Subject: Westinghouse Responses to NRC Request for Additional Information (RAIs) on "Optimized ZIRLO™" Topical – Addendum 1 to WCAP-12610-P-A and CENPD404-P-A (Non-Proprietary), TAC No. MB8041

**Westinghouse Responses to NRC Request for Additional Information
(RAIs) On Optimized ZIRLO™ Topical – Addendum 1 to WCAP12610-
P-A and CENPD404-P-A**

**Figure 3.1 Effects of Fluence Levels on Mechanical Properties
(ASTM STP 681 - article by K.Pettersson)**

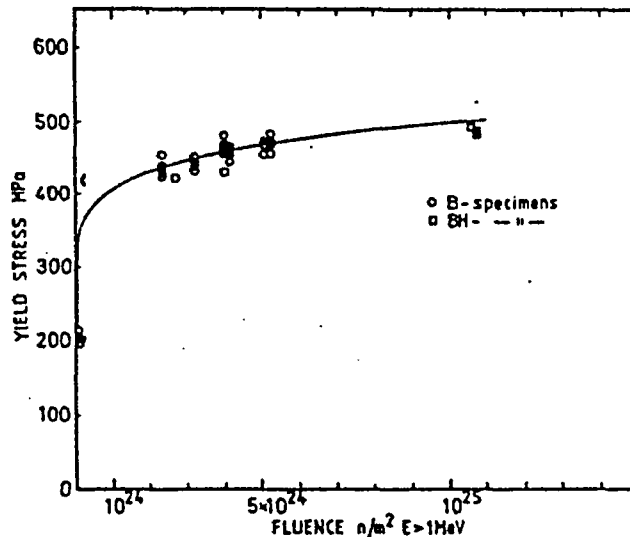
3. Irradiation experience with Optimized ZIRLO™ is discussed in Section 3.5.
 - a. In light of the limited database presented, justify the material properties up to 62,000 MWD/MTU.

The characterization testing reported in the addendum demonstrates that standard ZIRLO material properties currently used in various models and methodologies are applicable to analyses of Optimized ZIRLO. The primary effects of a reduced tin level in ZIRLO are a minor reduction in the un-irradiated mechanical strength and improvement in the corrosion resistance. The higher burn-up levels are associated with higher fluence levels. Since the precipitate structure remains the same for current and Optimized ZIRLO, the past performance of ZIRLO precipitate structure at high burn-ups also is similar to the Optimized ZIRLO condition.

Likewise, with the irradiation strengthening occurring during the initial irradiation, the Optimized ZIRLO performance will be the same as the current ZIRLO performance. The irradiation strengthening that occurs with the initial fuel operation negates the starting differences in mechanical strength. This effect has been reported in the general literature. An early example is found in ASTM STP 681 in an article by K. Pettersson on the effects of irradiation on the mechanical strength of Zircaloy tubes. Figure 3.1 is a copy of one of the figures in the report that shows that irradiation strengthening occurs very early in the initial operating cycle. The data shows that there is an initial period when at relatively low fluence (3×10^{21} n/cm²) the majority of the irradiation strengthening occurs. Data reported in ASTM STP 484 by D.H. Hardy on "The Effect of Neutron Irradiation on the Mechanical Properties of Zirconium Alloy Fuel Cladding in Uniaxial and Biaxial Tests" indicates that (a) strengthening occurs during the initial

irradiation, (b) for large differences in starting conditions the strength differences are not fully eliminated at 3×10^{21} n/cm² and (c) after about 3×10^{21} n/cm² the 0% cold worked structure has a strength similar to the un-irradiated cold worked material. Information from hot cell testing of irradiated thimble tubes and cladding confirms the effects of irradiation strengthening in reducing/negating the strength differences initially present in the starting un-irradiated material. Due to processing differences the standard ZIRLO thimble tubes have a lower un-irradiated strength []^{a, b, c} compared to un-irradiated fuel cladding. As shown in the data table included in the response to RAI #25, measured strengths of cladding and thimble tubes show a significant difference in un-irradiated strengths but upon irradiation the mechanical strengths of both the thimble tube and the cladding are increased to similar levels. The difference in un-irradiated mechanical strengths between Standard ZIRLO and Optimized ZIRLO is much less than the corresponding difference between cladding and thimbles. The strength increase due to irradiation is generally beneficial and provides additional margin between stress and stress criteria.
